CITY OF NEW YORK
DEPARTMENT OF ENVIRONMENTAL PROTECTION
BUREAU OF ENGINEERING DESIGN & CONSTRUCTION
WM-30 WATERSHED IMPROVEMENTS
RECONSTRUCTION OF
CATSKILL WATERSHED DAMS AND ASSOCIATED FACILITIES

GILBOA DAM AND ASSOCIATED FACILITIES RECONSTRUCTION
CONTRACT CAT-212B
ARCHITECTURAL
DAM RECONSTRUCTION
DETAILS - SHEET 5 OF 5

90% SUBMITTAL

DETAIL AT GUARDRAIL CORNER

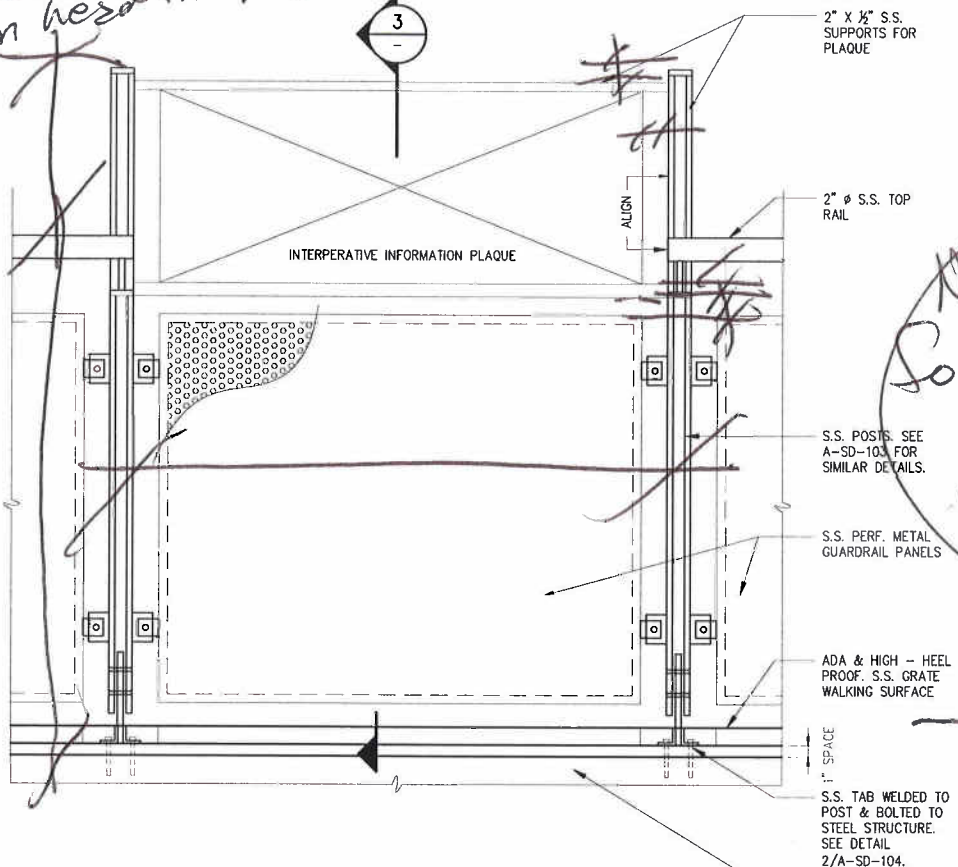
suggest 3" I've seen kids run head in 4" slot what is NYC code? 6" ball

ENLARGED ELEVATION OF MONOLITH PATTERN
1"=10'

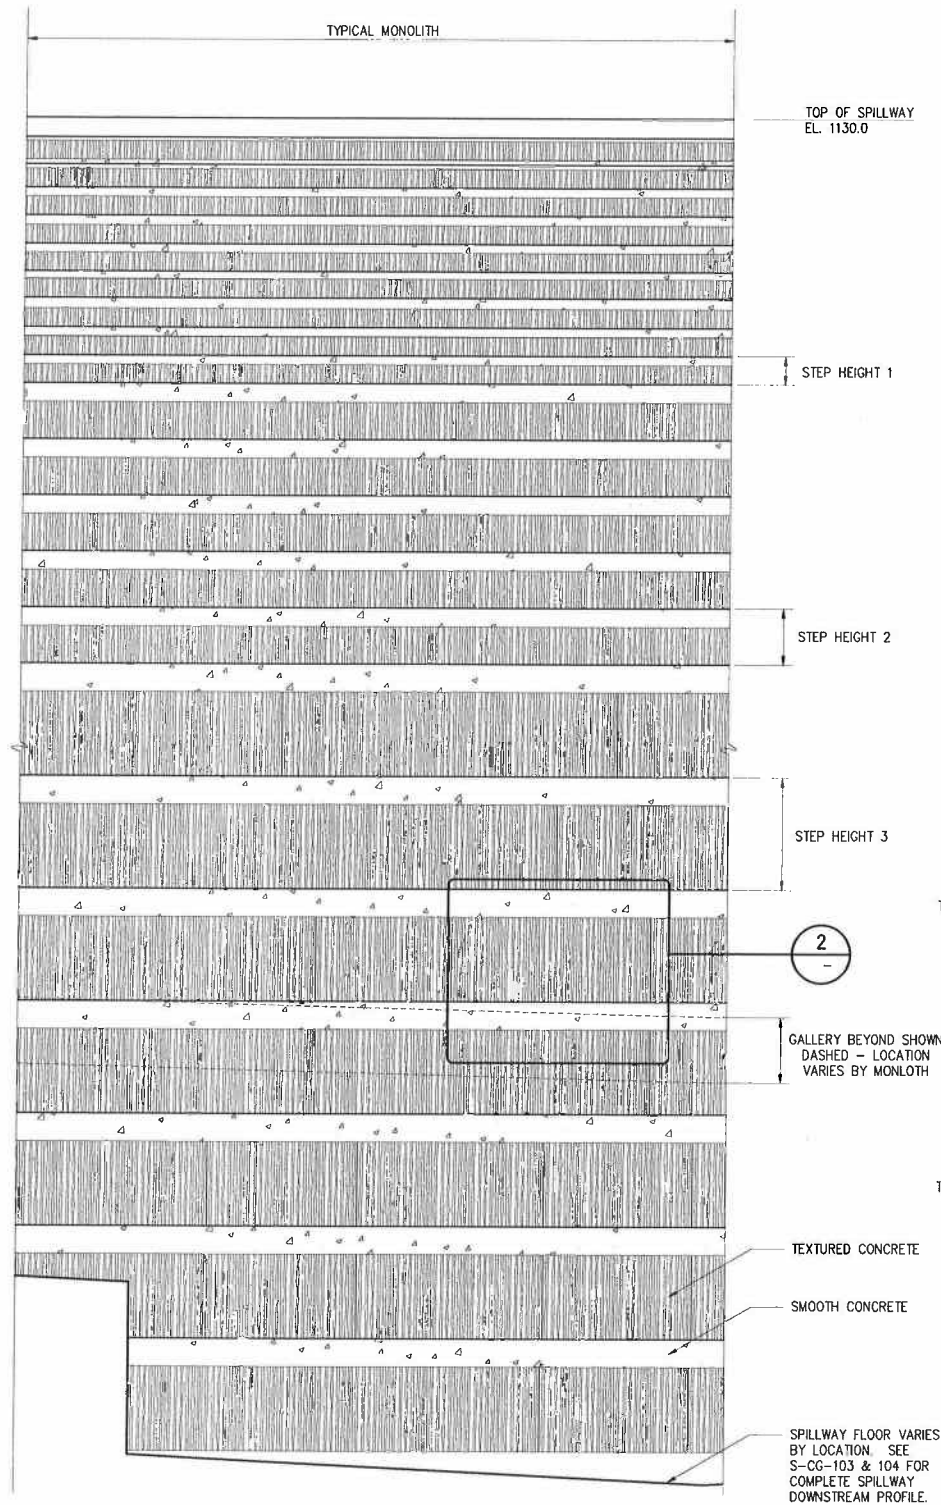
Is this supposed to be this
don't match
if so

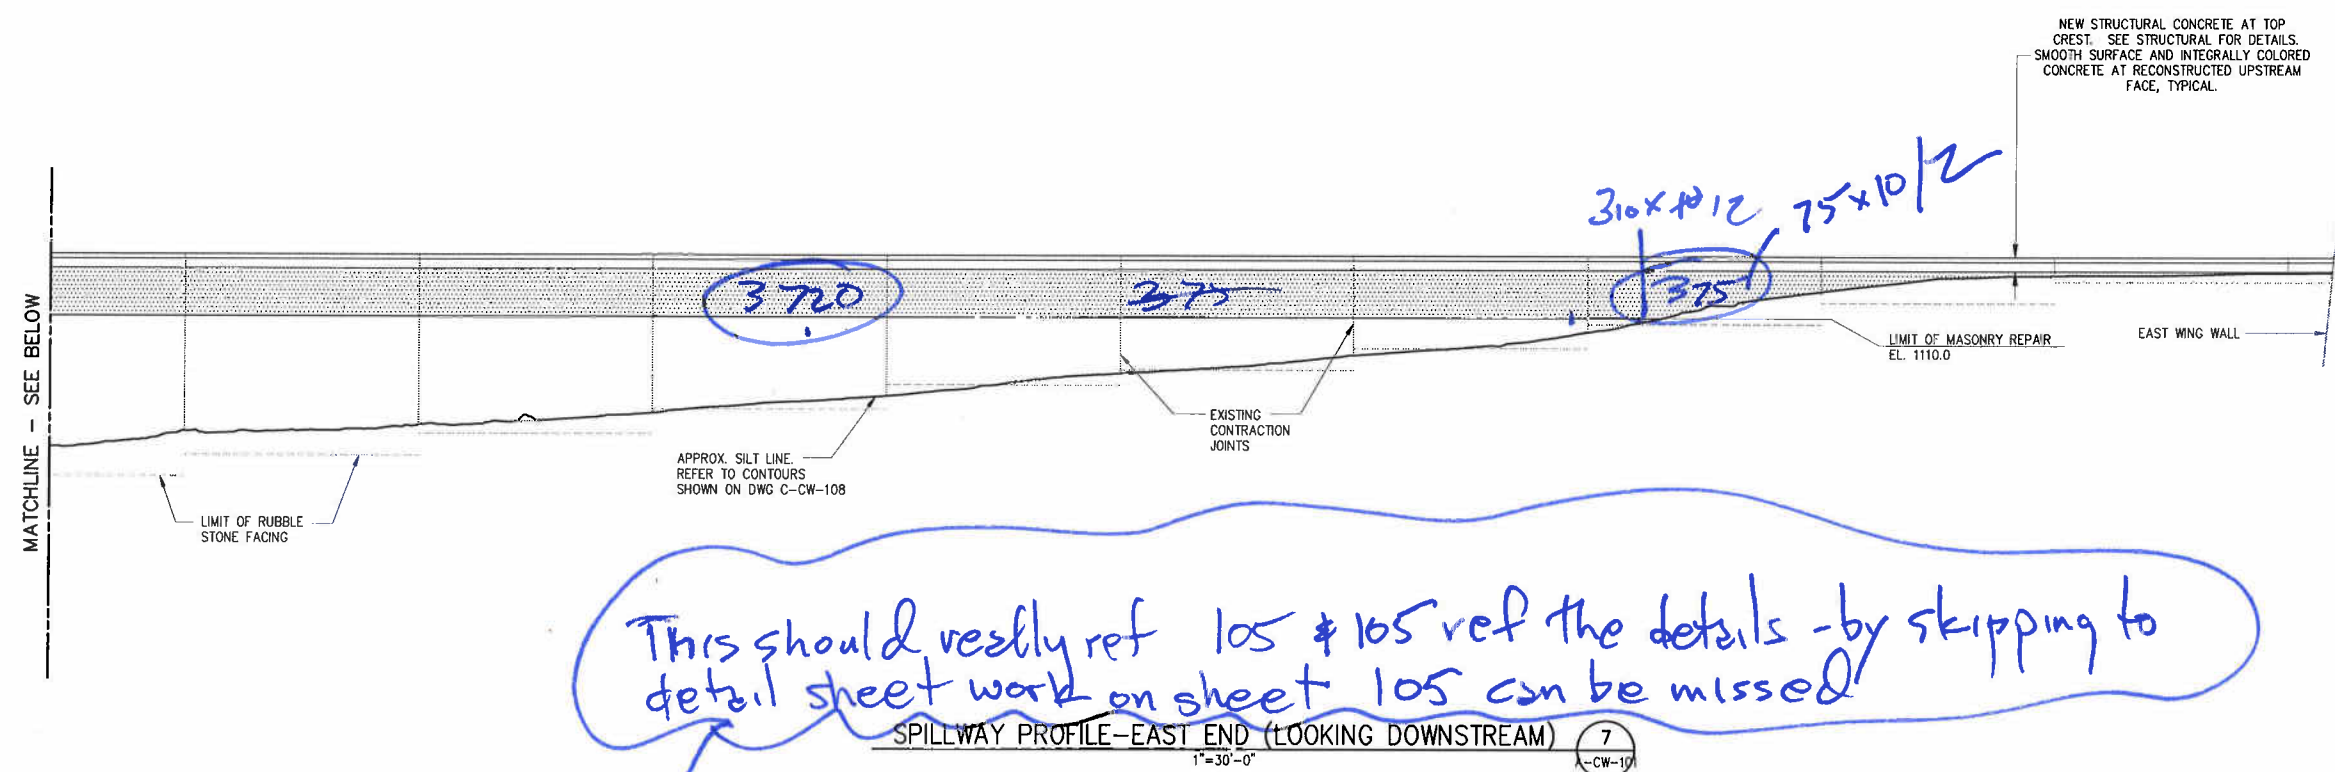
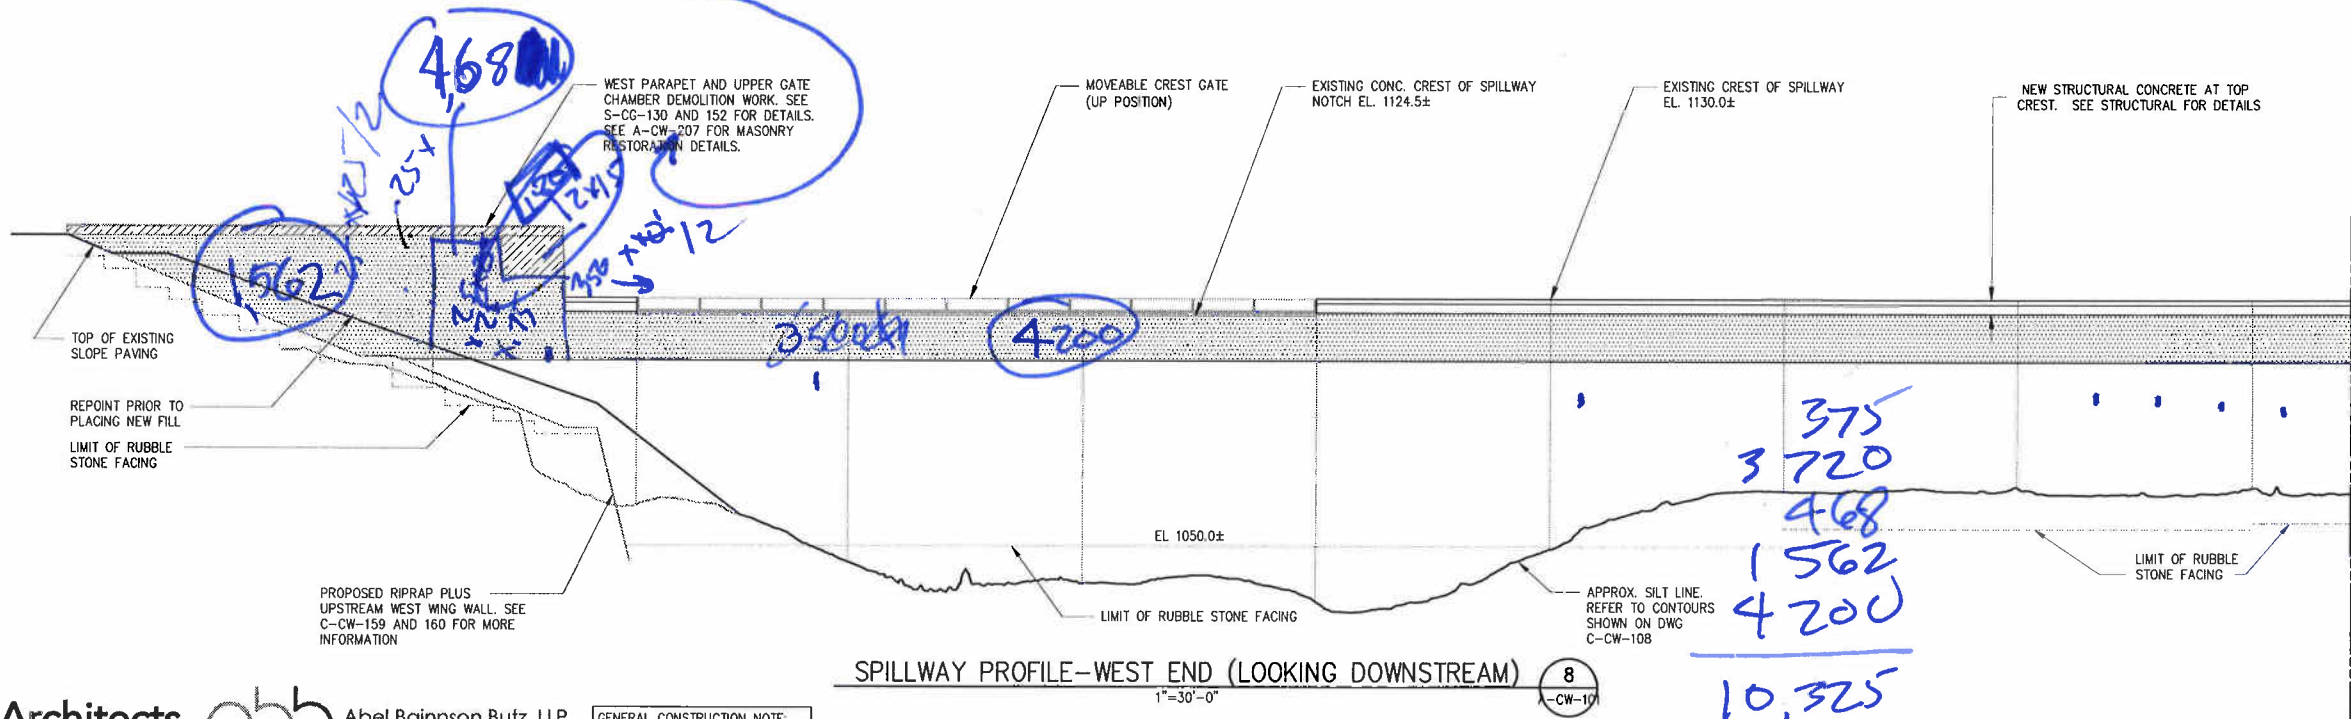
This should really ref 105 & 105 ref the details - by skipping to detail sheet work on sheet 105 can be missed

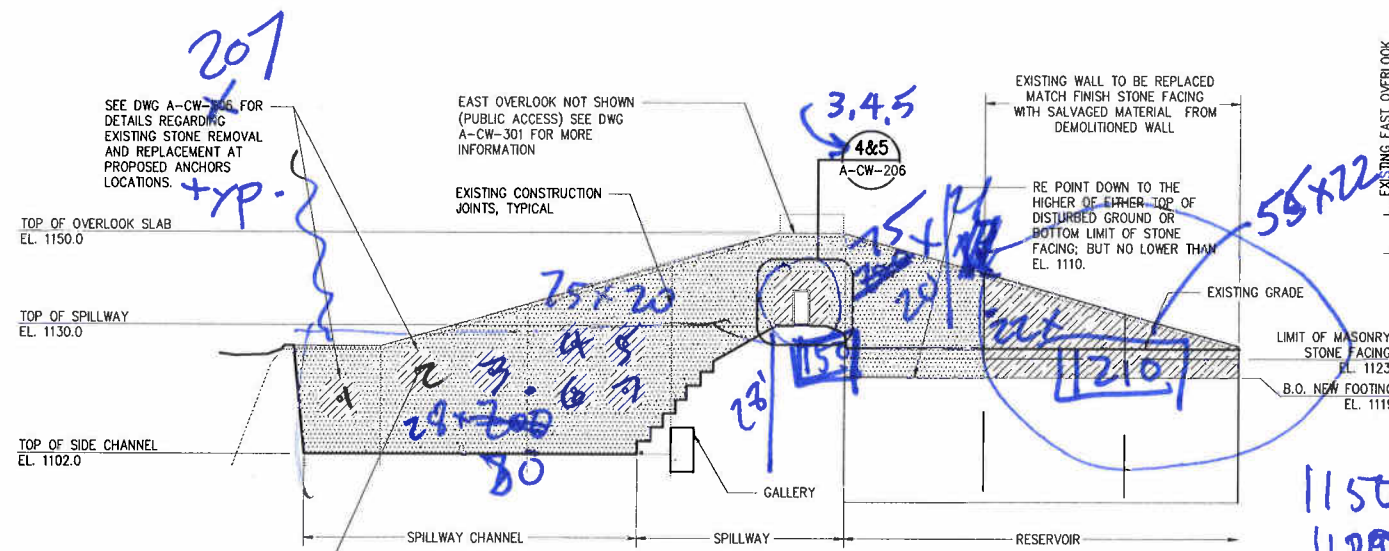
12 size make 2 not 1 pg or
move to A-CW-101 & call general notes applicable to ALL work

fill in maybe
if not spec'd add
Photograph each area
utilizing a key to plan
note ensure

copy & replace these notes
copy note here

EXISTING EAST OVERLOOK PARAPET DEMOLITION

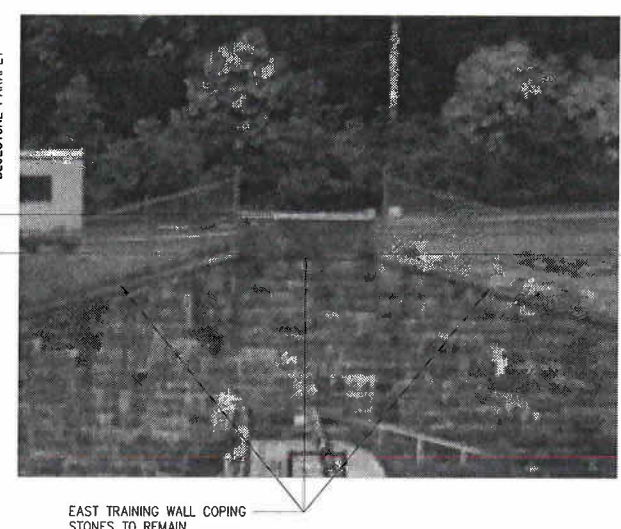
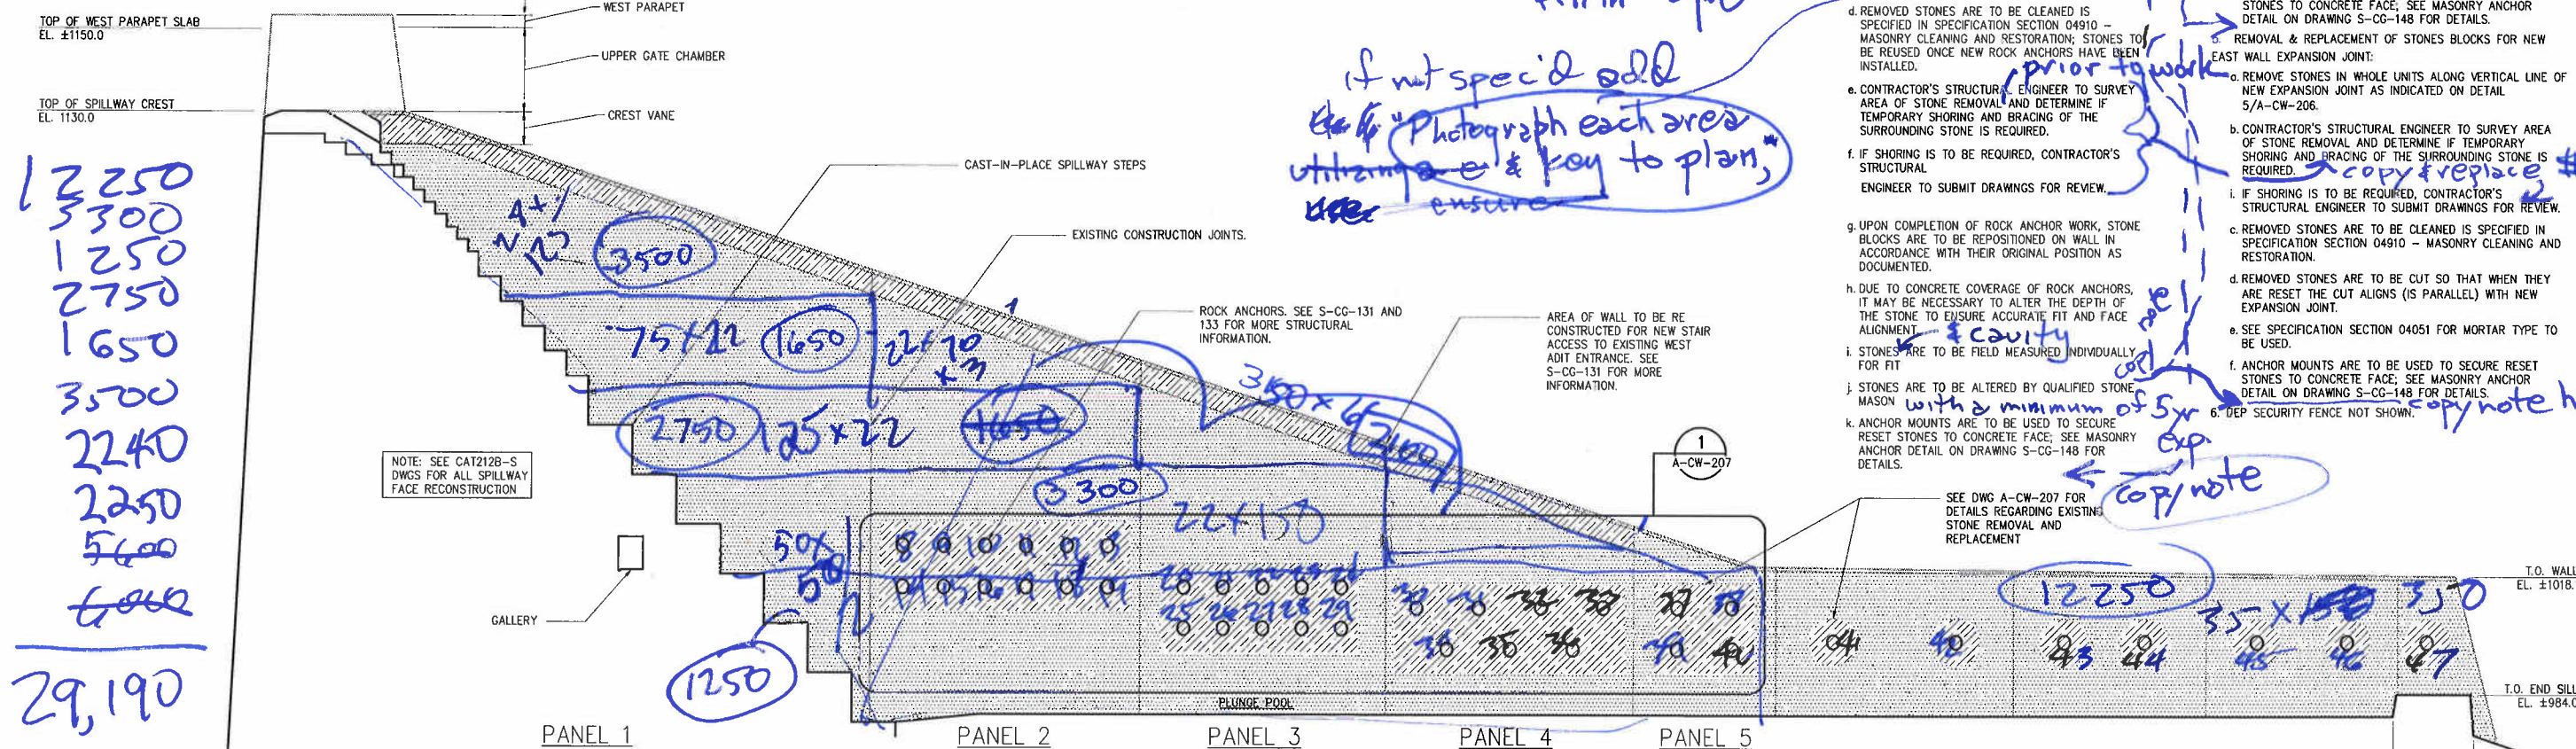
This dwg has 3 details numbered 4, 2 & 6 ?? why not 1, 2 & 3?
90% SUBMITTAL
